Crystal River Nuclear Plant
Docket No. 50-302
Operating License No. DPR-72

Subject: Crystal River Unit 3 – Non-Proprietary version of the Supplement to Proposed License Amendment Request #277, Revision 0, “BHTP Departure From Nucleate Boiling Correlation”

**LICENSE AMENDMENT REQUEST #277, REVISION 0
BHTP Departure From Nucleate Boiling Correlation
Non-Proprietary Supplemental Information**

Figure 1

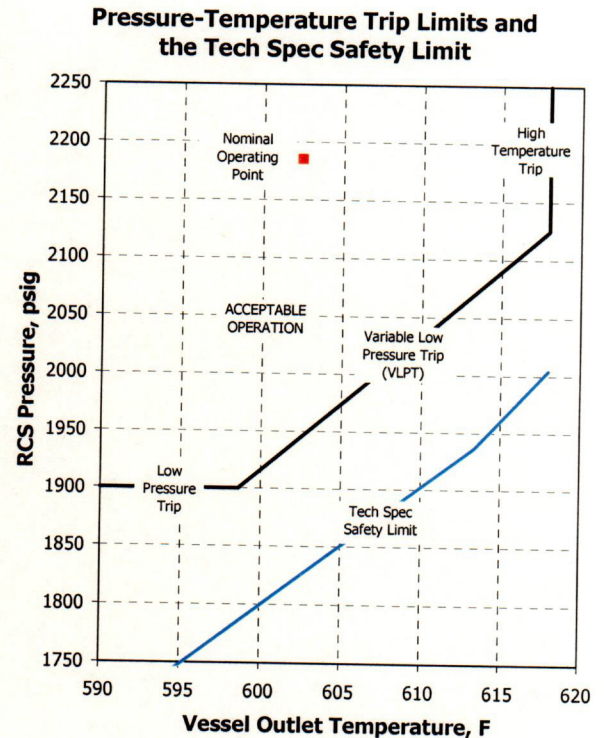
REQUEST 1: Explain why the current Improved Technical Specification (ITS) Figure 2.1.1-1 safety limit line remains applicable and bounding for the Mark-B-HTP fuel design evaluated with the BHTP DNB correlation.

The DNB-based safety limit line presented in Improved Technical Specification (ITS) Figure 2.1.1-1 for CR-3 Cycle 14 application reflects no change in the current Cycle 13 DNB-based safety limit line. The acceptability of applying the same safety limit line for Cycles 13 and 14 is a result of the significant conservatism contained within the Tech Spec safety limit line. The safety limit line shown in Figure 2.1.1-1 was generated and applied in the 1970's for CR-3. It was based directly on the thermal-hydraulic codes, methodologies, CHF correlations, and fuel designs that Babcock & Wilcox used at that time for CR-3. The variable low pressure trip (VLPT) function is used to provide the necessary protection that the plant does not operate at the RCS pressures and temperatures that would exceed or violate the Tech Spec safety limit line (see Figure 1).

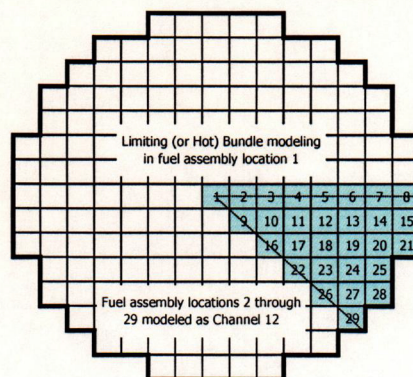
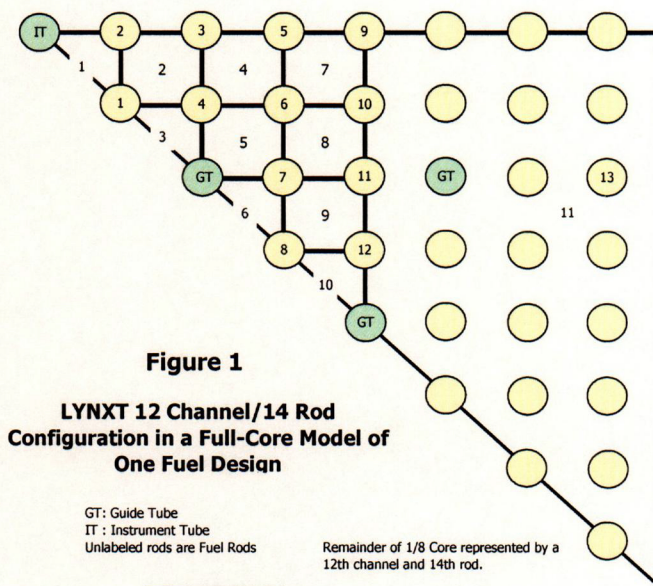
REQUEST 2: Explain how the mixed core DNB penalty has been determined using LYNXT for a conservative configuration of Mark-B-HTP and co-resident fuel designs.

For CR-3 Cycle 14, Framatome ANP modeled a full core with 177 Mark-B-HTP fuel assemblies (using a 1/8 core symmetry model with LYNXT) as shown in Figure 1. This model is composed of 12 channels. The limiting, or hot, bundle is modeled at the core center.

Channels 1 through 10 represent individual subchannels. Channel 11 represents the remainder of the hot bundle. Channel 12 represents the remainder of the core. The limiting location for the placement of the hot pin is Rod 6 for the BHTP correlation (Reference 2). The limiting fuel rod is modeled as a $1.800 F_{\Delta H}$ with a 1.65 symmetric axial power shape.

Figure 2

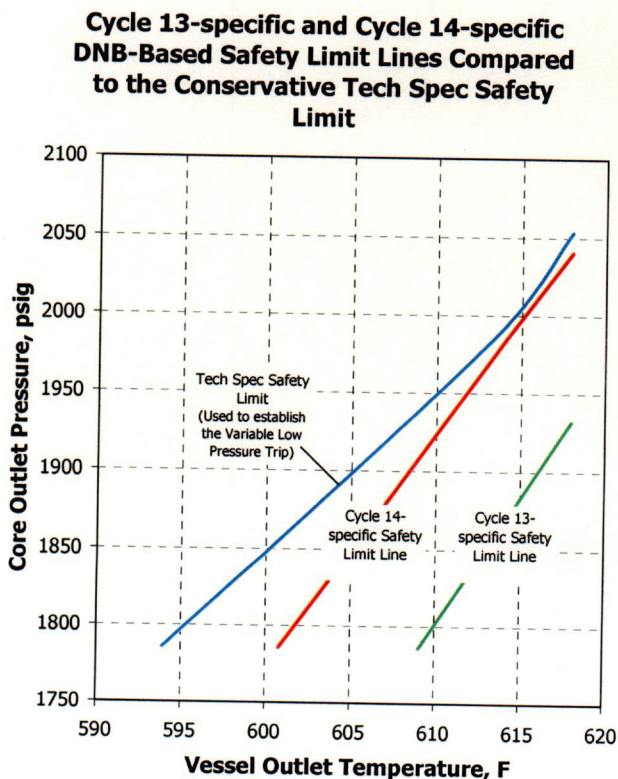
REQUEST 3: Explain the Cycle 14-specific DNB results obtained using the BHTP DNB correlation.

The Cycle 14-specific safety limit line shown in Figure 2 is based on a TDL of []. This TDL value adequately covers the transition core DNB penalty discussed in EXPLANATION 2. The TDL is also
